TO : All Bidders  
FROM : George M. Wiens  
PROJECT : CTE Classroom Addition  
Vista Murrieta High School  
1615400.41  
SUBJECT : Addendum 2  
DSA : 04-115755 / 33-H18

Addenda No. 2 – Scope of Work Questions

DRAWING NUMBER: **E3.1**

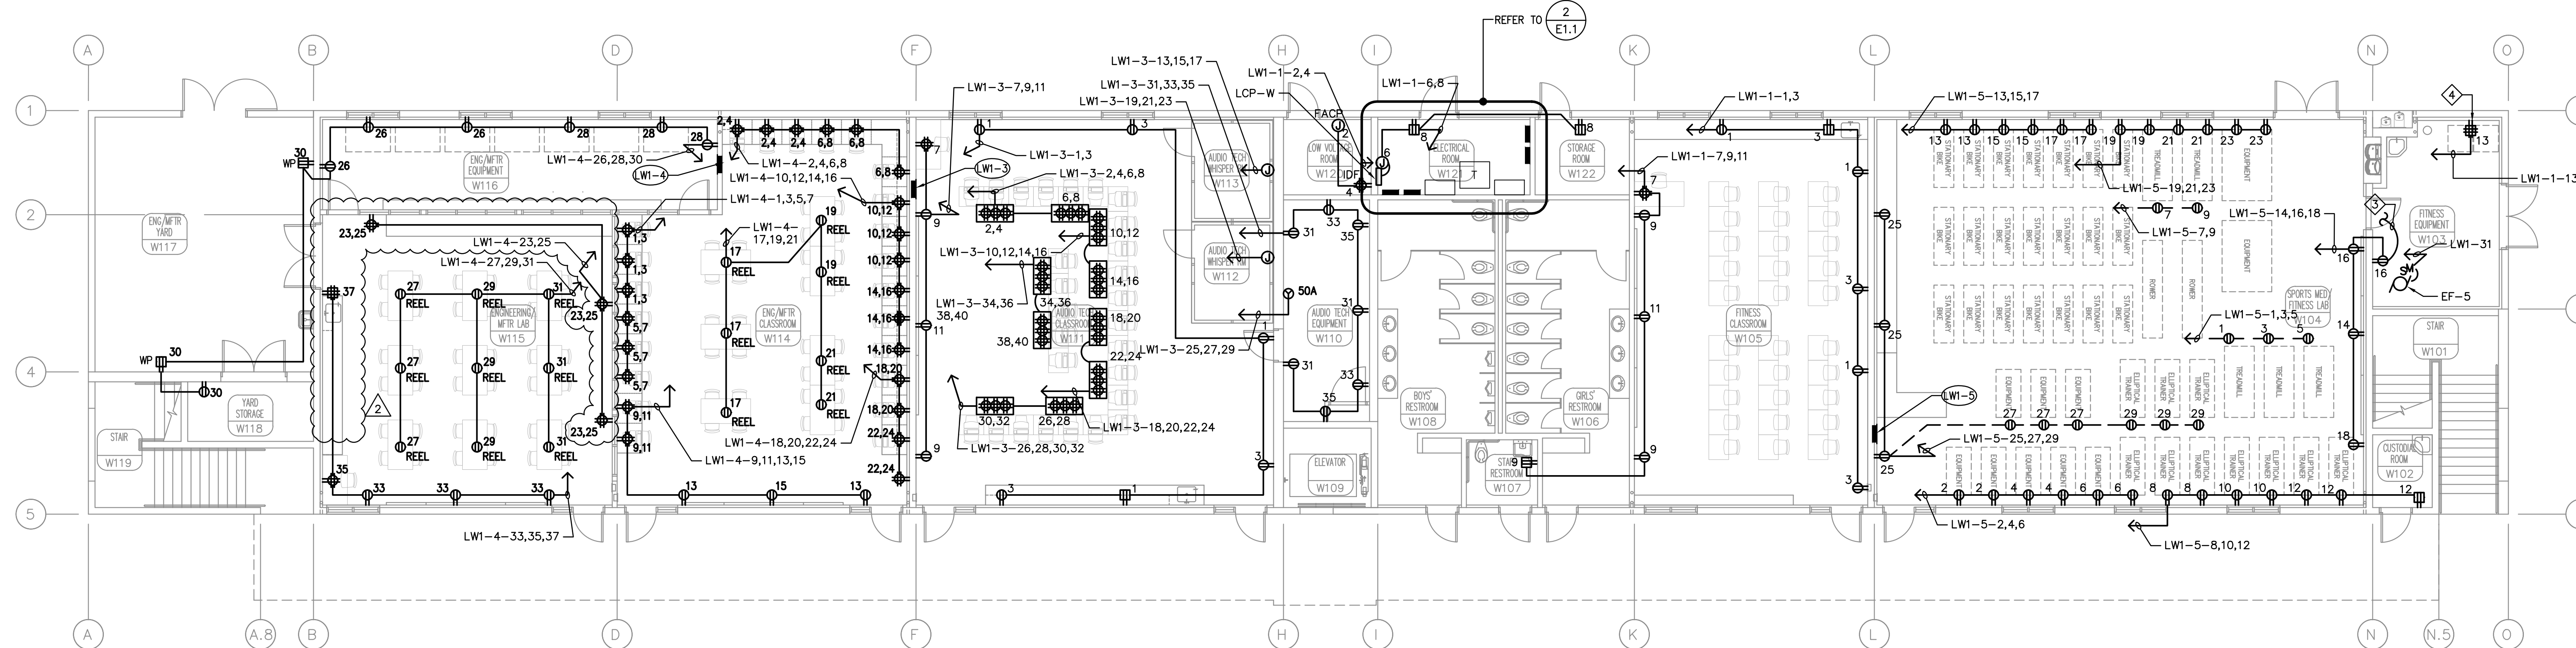
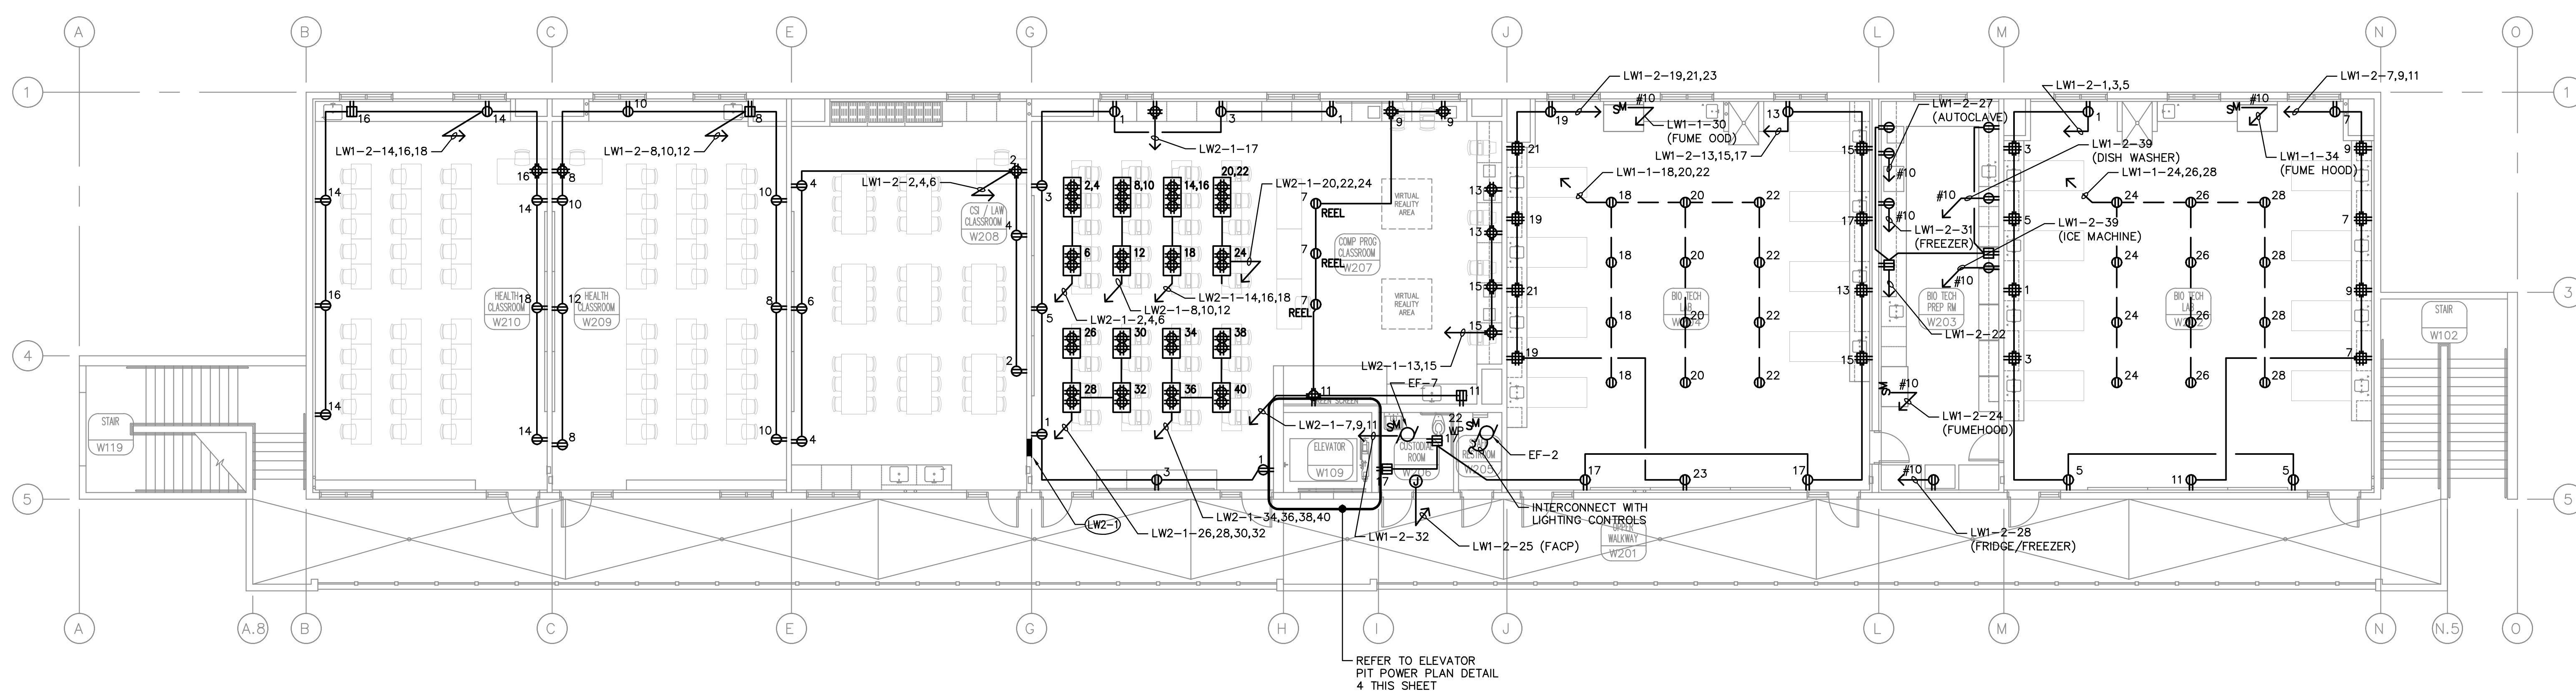
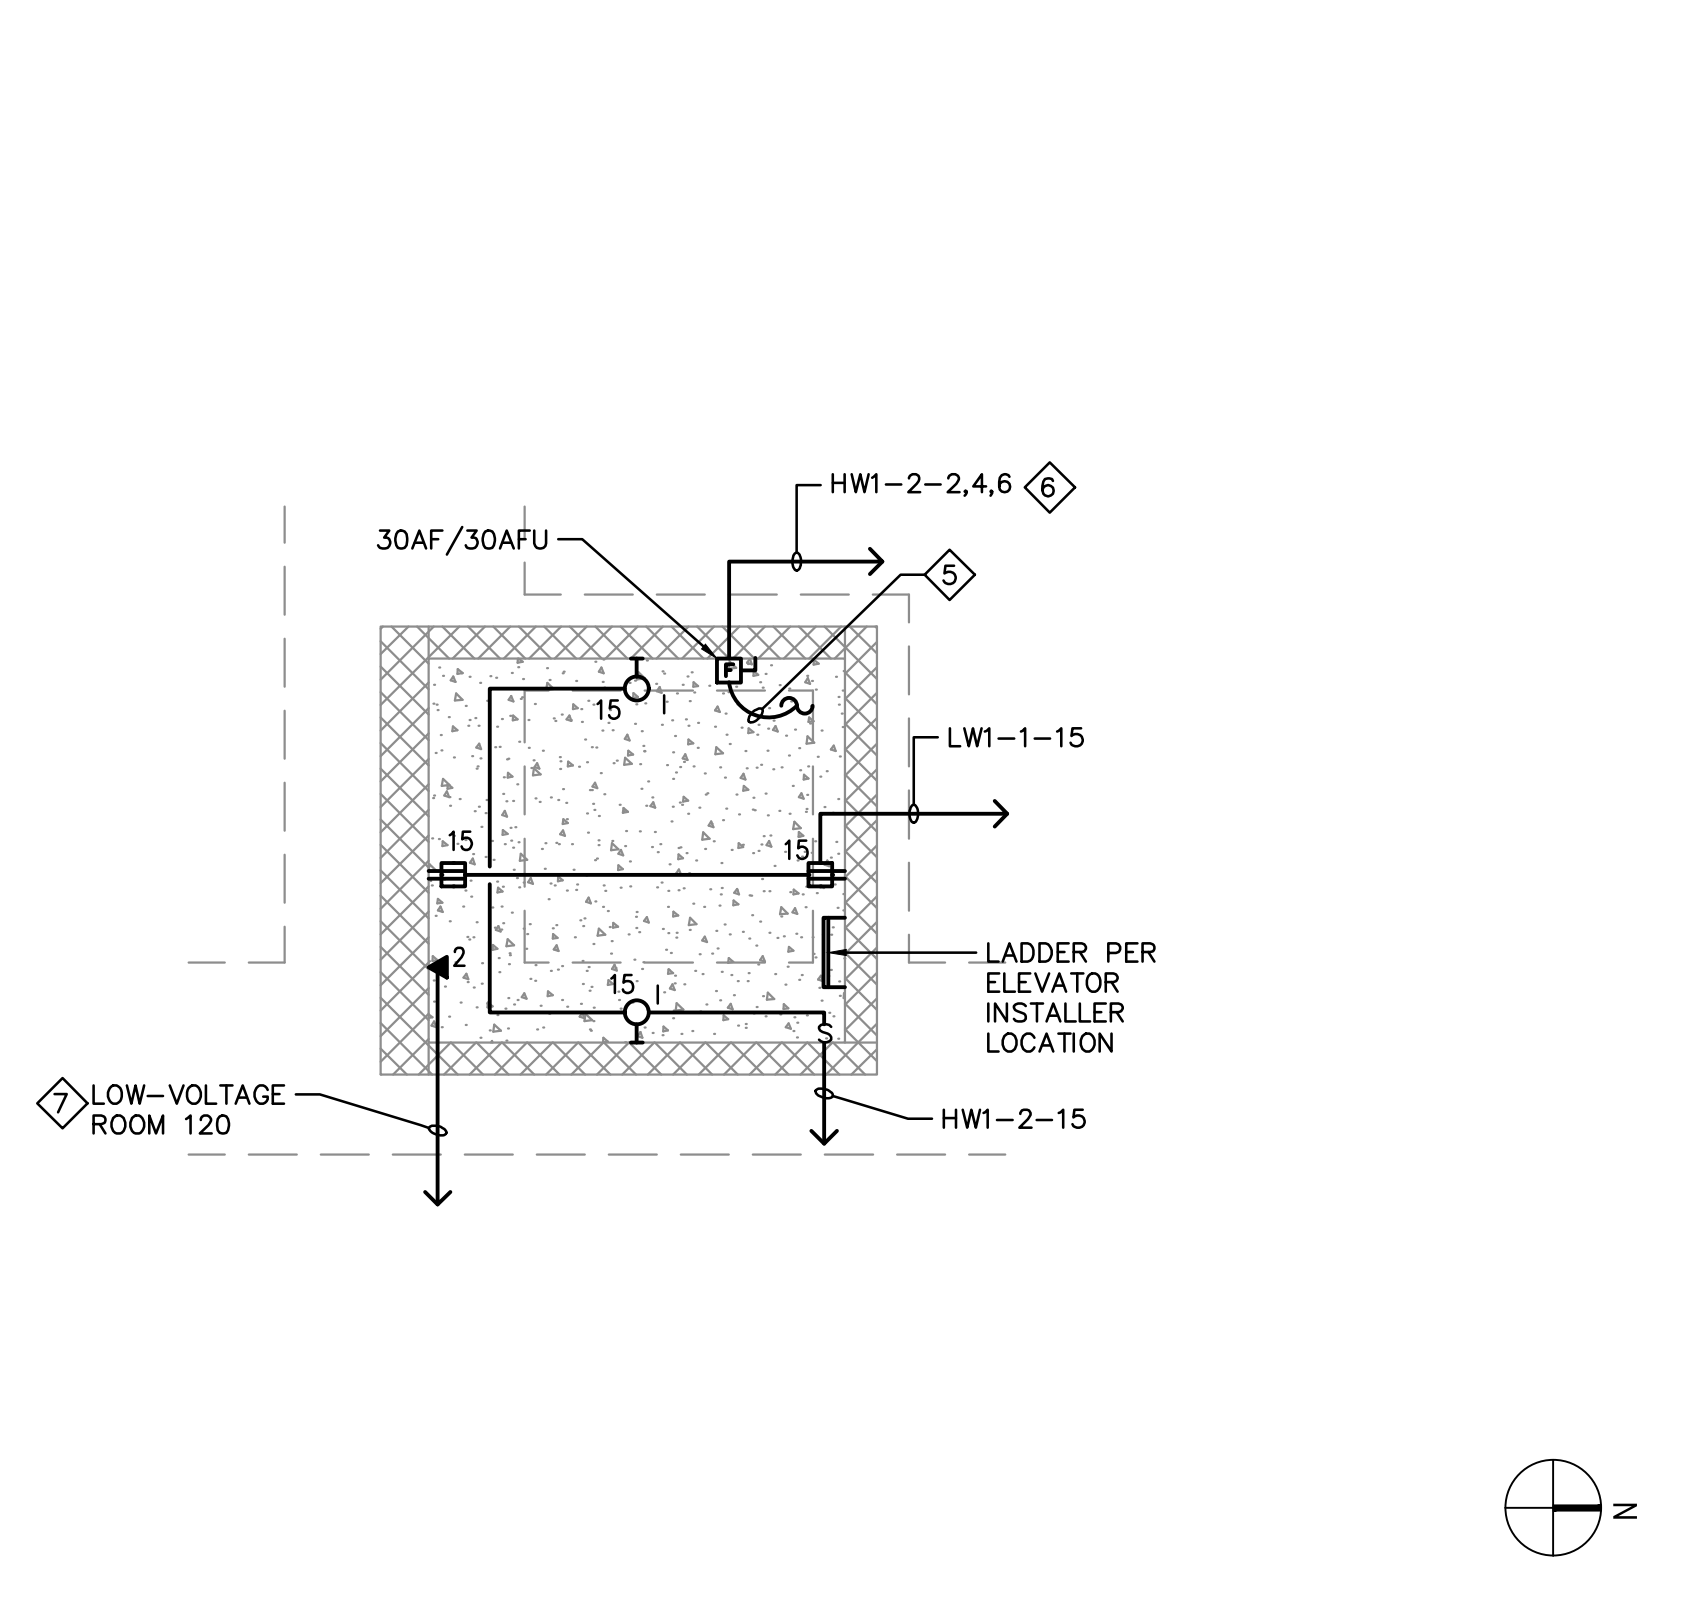
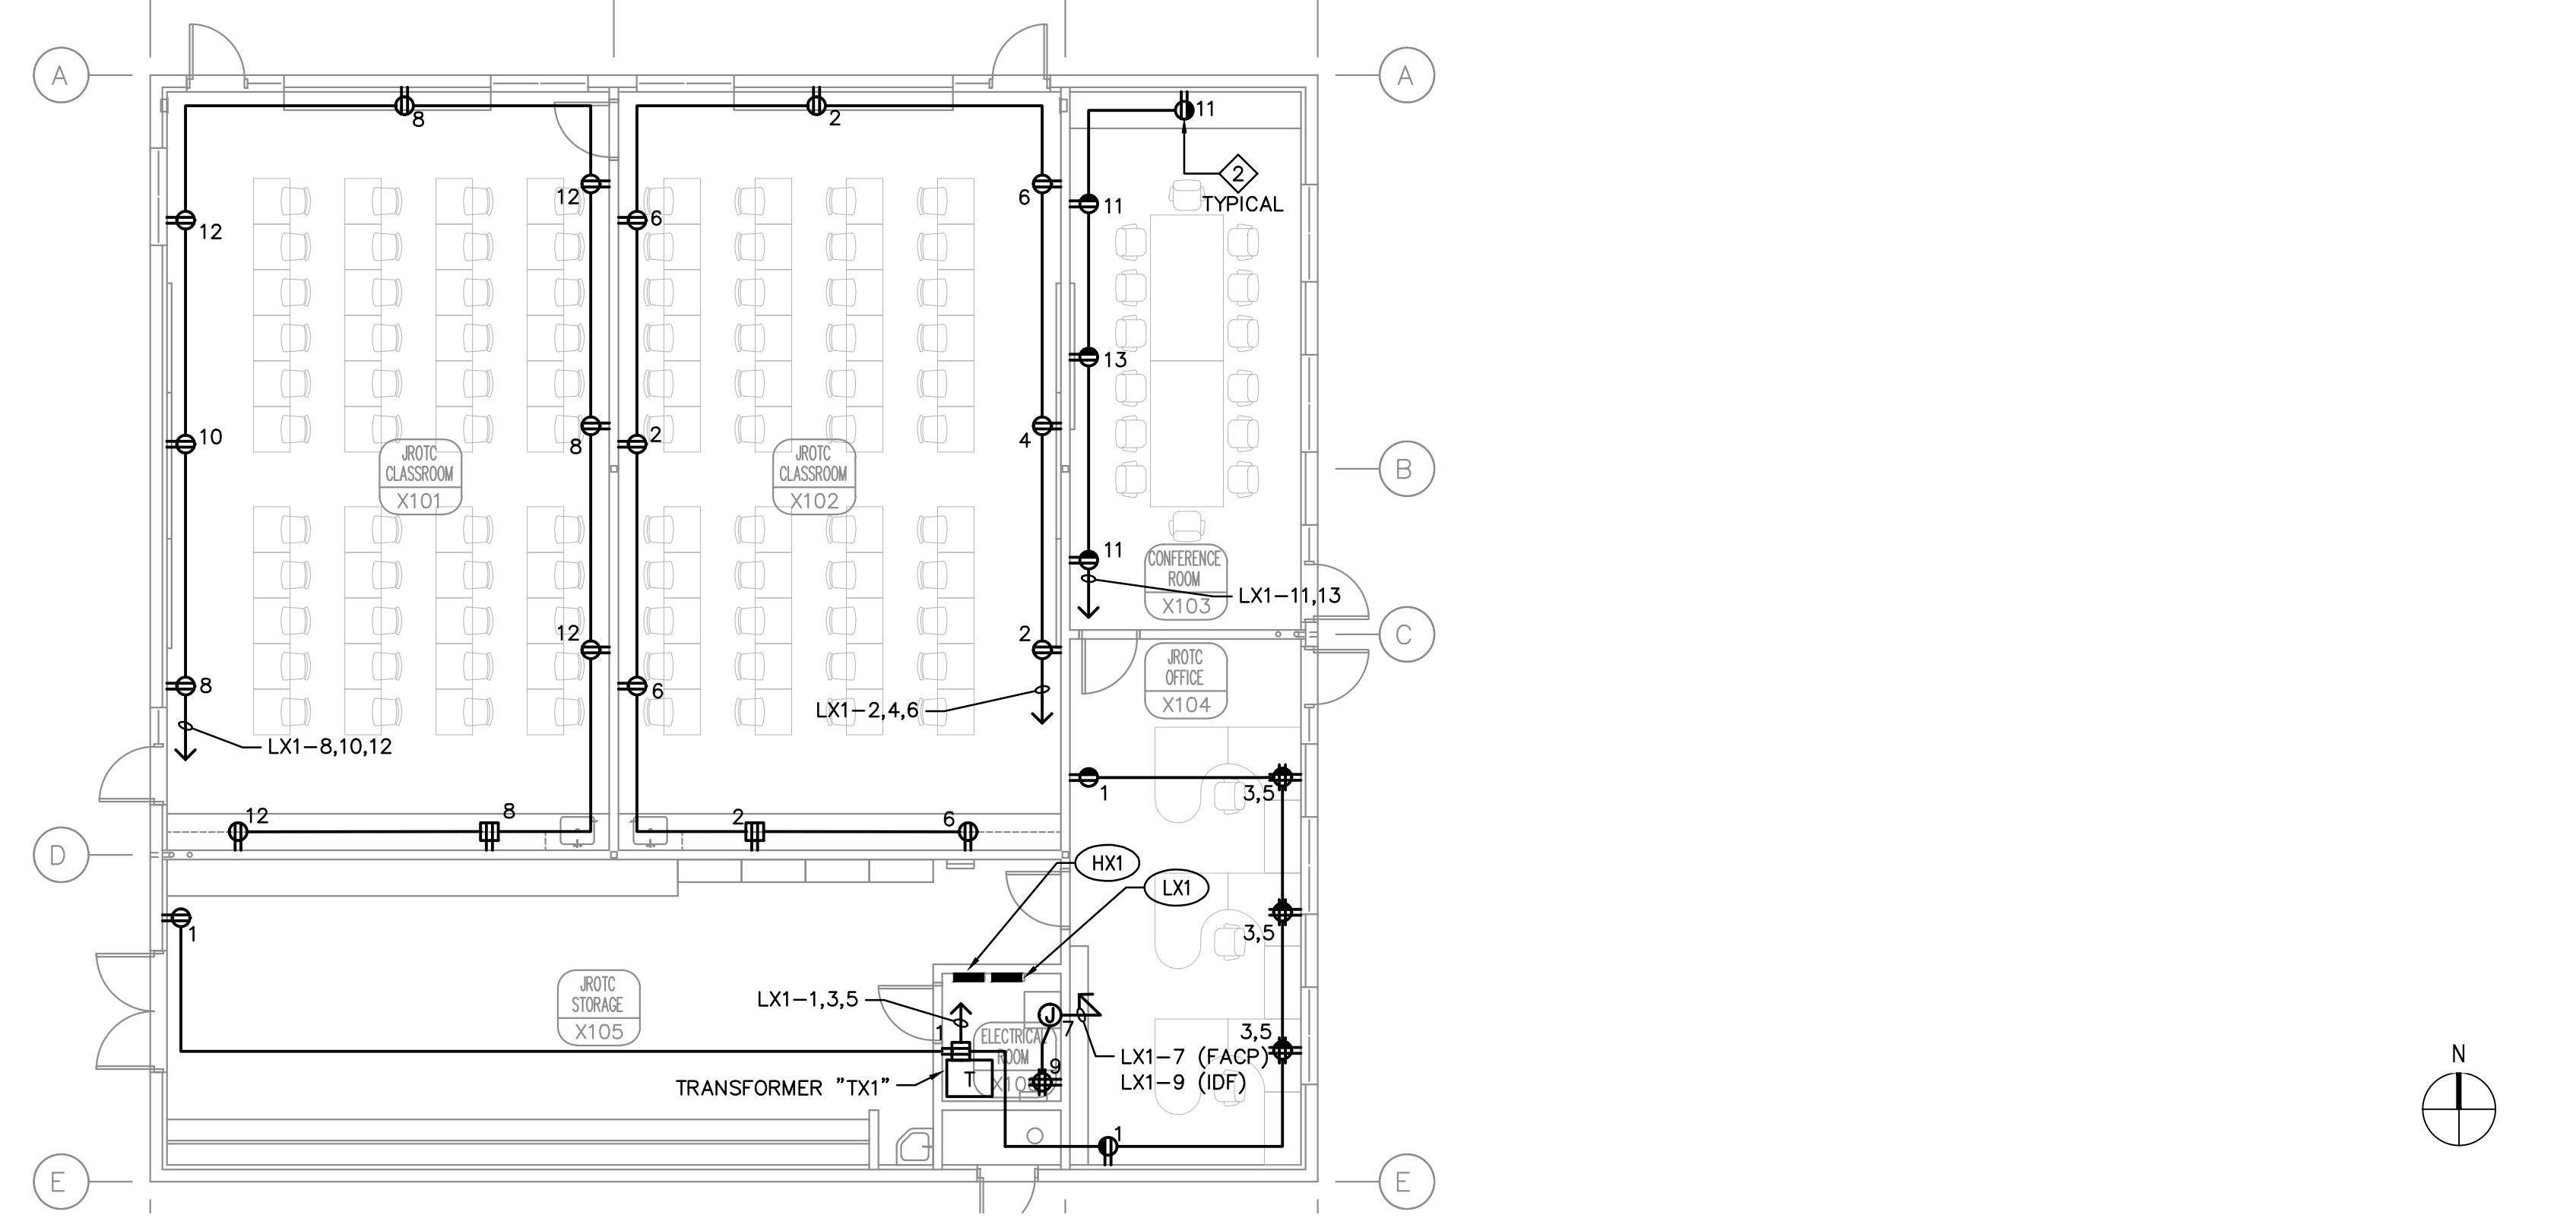
A. Revise as indicated in the clouded area labeled Delta 2 on the attached E3.1.
